**REVISED RESPONSE TO REQUEST FOR ADDITIONAL INFORMATION****APR1400 Design Certification****Korea Electric Power Corporation / Korea Hydro & Nuclear Power Co., LTD****Docket No. 52-046**

**RAI No.:** 252-8299  
**SRP Section:** 03.07.02 – Seismic System Analysis  
**Application Section:** 3.7.2  
**Date of RAI Issue:** 10/19/2015

**Question No. 03.07.02-7**

Figure 4. Tapered Section in Primary Shield Wall

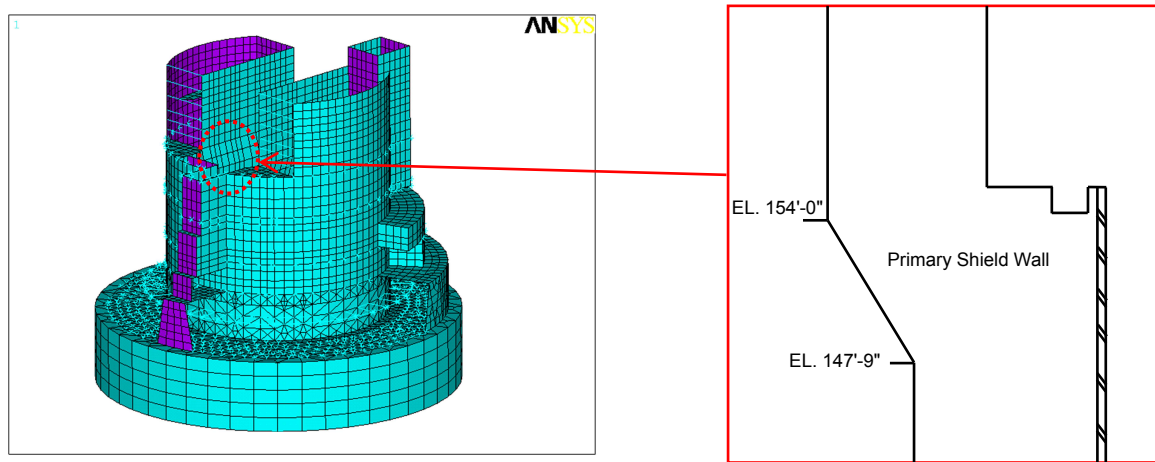
c) Shell Elements in Primary Shield Wall

As described in Section 3.2.10 and shown Figure 3-3 in APR1400-E-S-NR-14002-P, shell elements are used to model the shield wall portion of the primary shield wall (PSW) from EL 130' to EL 191.' Given the geometry of the PSW, the use of thick shell elements may be more appropriate for this portion of the PSW. he geometry of the PSW, the use of thick shell elements may be more appropriate for this portion of the PSW. Additionally, based on Figure 3-3, a portion of these walls modeled with shell elements, appears to be not in plane with respect to the plane of each respective wall. Therefore to assist the staff in evaluating the adequacy of the FEM for the PSW, the staff requests the applicant to clarify why the shell element selected for the PSW model is appropriate as opposed to using a thick shell element formulation. Additionally, please describe the modeling approach and the basis of the shell portion of the walls including the location of plates oriented in non-parallel planes.

- c) The original SASSI program was developed in the 1980's and has only the LCCT9 thin shell element, which was adopted from the SAP IV structural analysis program. This same version of the SASSI code was adopted by many company-specific versions of SASSI. ACS SASSI 2.3 also has only the LCCT9 thin shell element. Many versions of SASSI, including ACS SASSI 2.3, do not have thick shell element available for structural modeling. This is the reason why thick shell elements have not been used for modeling the PSW by the ANSYS program.

Use of thick or thin shell elements does not significantly affect the overall structural stiffness since the main stiffness of the shell structures (containment shell, PSW, SSW, etc.) are primarily due to in-plane stiffness.

The thickness and center axis of the PSW section are changed over EL. 147'-9" through EL. 154'-0", as shown in Figure 4. The portion of wall which is not in plane with respect to the plane of respective walls in Figure 3-3 of APR1400-E-S-NR-14002-P was intentionally modeled to represent the contour of the PSW.

Figure 5. Connection between RCS Supports and Solid Elements

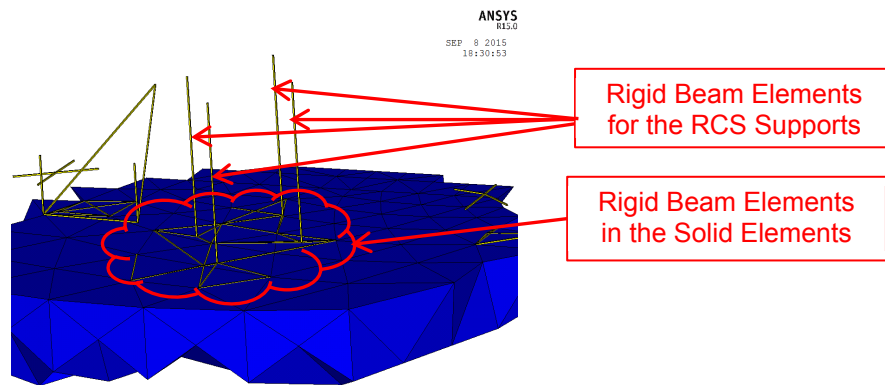
d) Transitions between Beam and Solid Elements

Staff review of APR1400-E-S-NR-14002-P finds that the nuclear island finite element model includes locations at which beam elements connect with solid elements (e.g. connections between the reactor coolant system model and the containment internal structure model). However, the staff did not find a description of how the degree of freedom compatibility is addressed for transitions between beam and solid elements. Therefore the staff requests the applicant to provide such description, including a graphical representation of the transition between beam and solid elements.

- d) The degrees of freedom compatibility condition between the beam elements of the reactor coolant system (RCS) and solid elements of the primary shield wall (PSW) and the secondary shield wall (SSW) was satisfied by using the rigid beam elements at the beam-to-wall support points covering the footprint of the RCS support brackets. The RCS supports are modeled as rigid beam elements and connected with other rigid beam elements in the solid elements which represent the PSW and the SSW.

Figure 5 shows the connection between the RCS supports (rigid beam) and the building model (solid elements). Technical report APR1400-E-S-NR-14002-P will be revised, as indicated in Attachment 3 to this response to incorporate the description of the beam-to-solid element connection.
